Town of Hilton Head Island Regular Design Review Board Meeting

October 27, 2015

AGENDA

**Town of Hilton Head Island
Design Review Board
Minutes of the Tuesday, October 13, 2015 Meeting
1:15p.m. – Benjamin M. Racusin Council Chambers**

FRONT ELEVATION
(FACING PEMBROKE DRIVE)

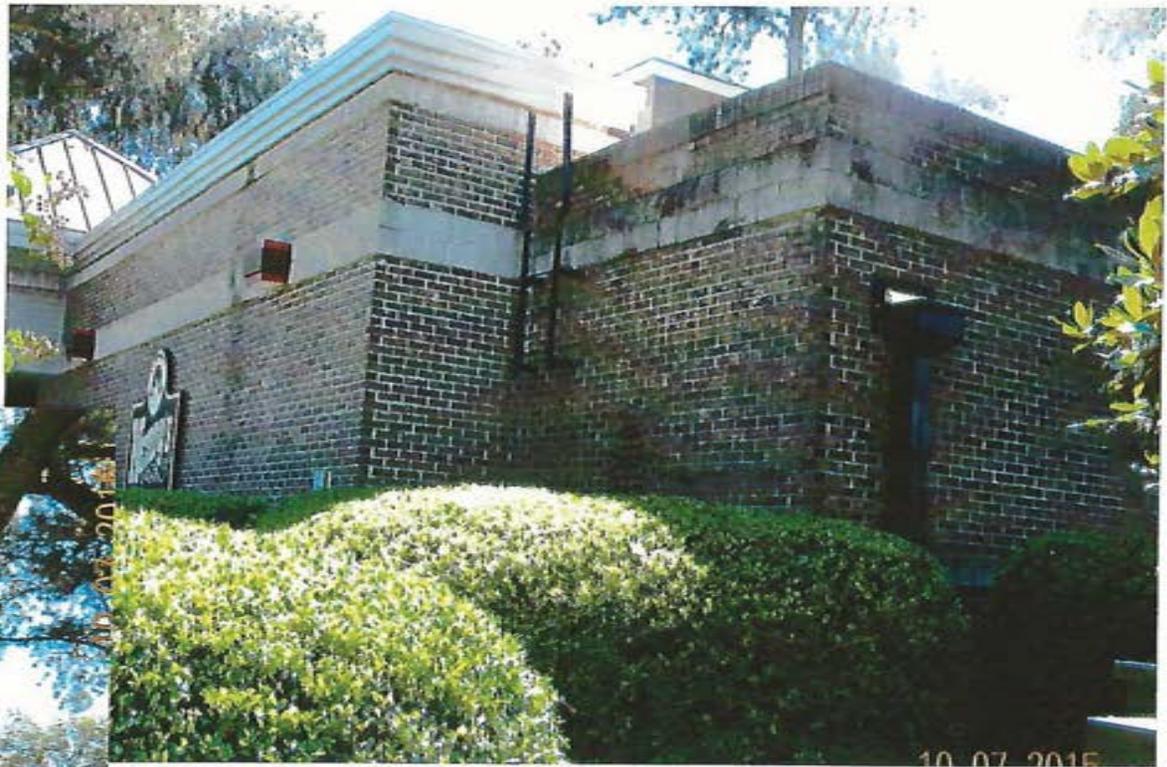
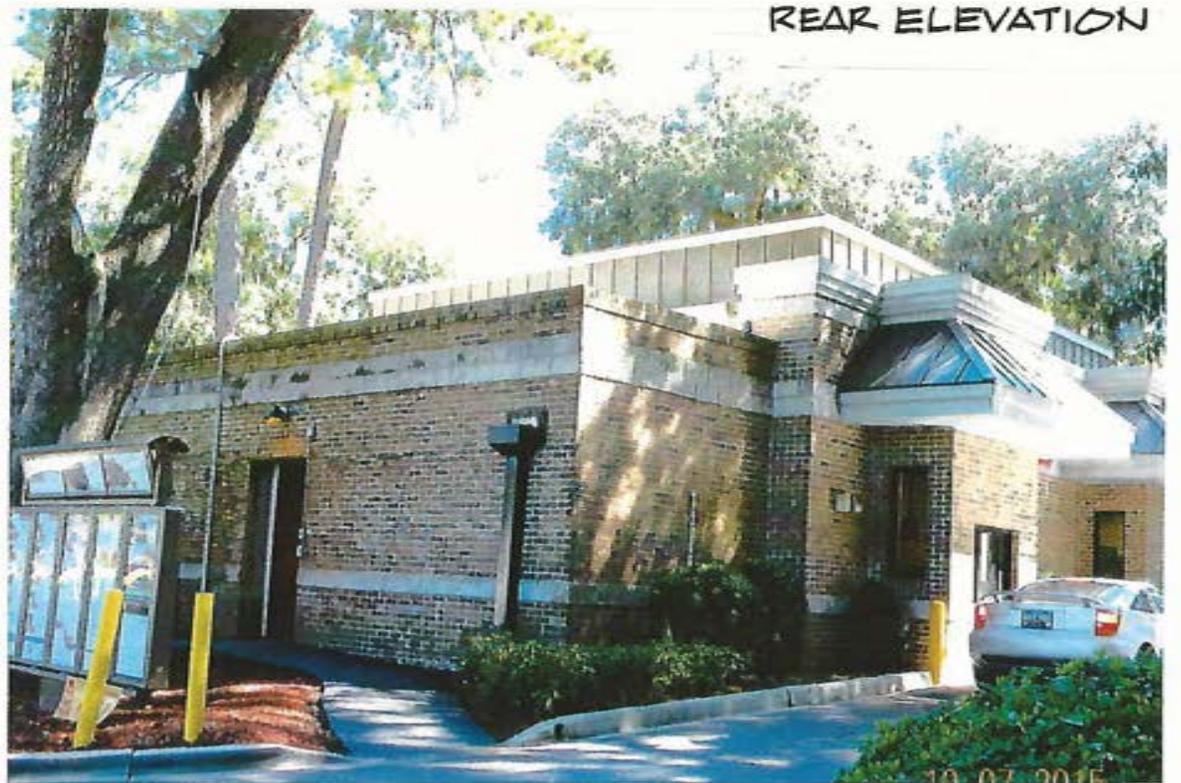
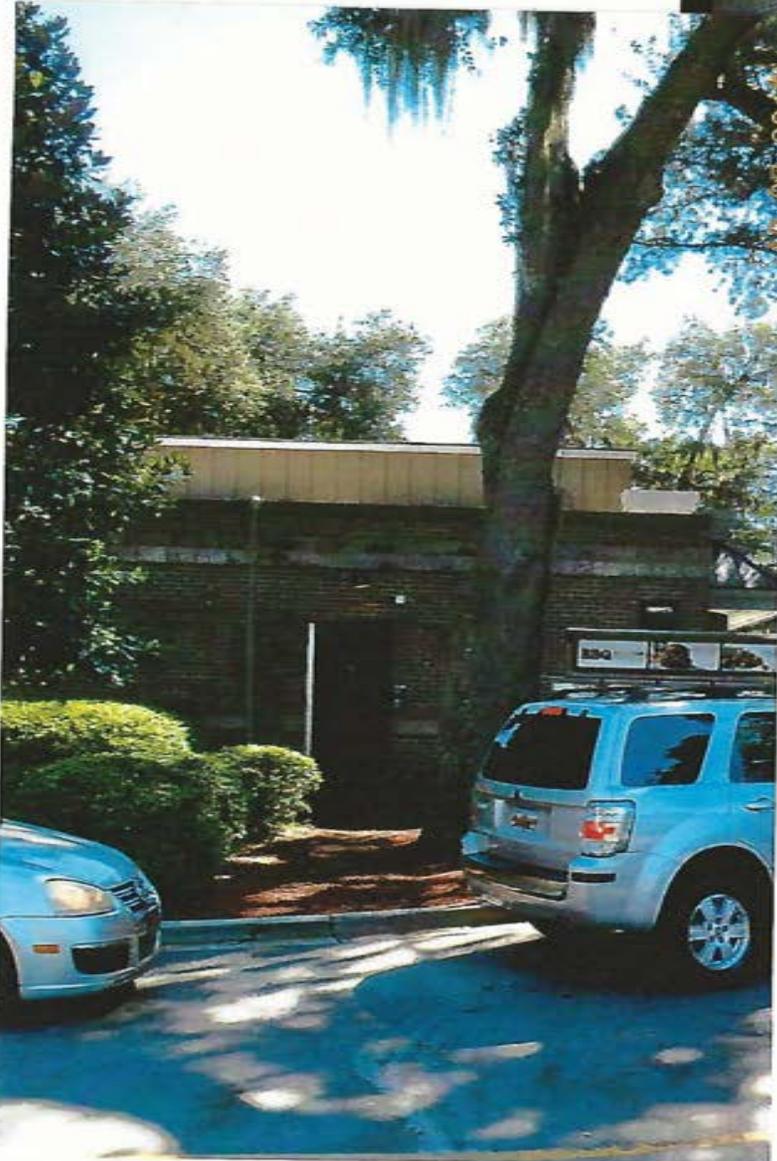
Applicant proposes to renovate existing Wendy's to include installing nichia wall panels over existing upper brickwork, painting existing metal fascia dark bronze, and painting existing sconces dark bronze. "Black out" screening will be added at two windows facing Pembroke Drive.
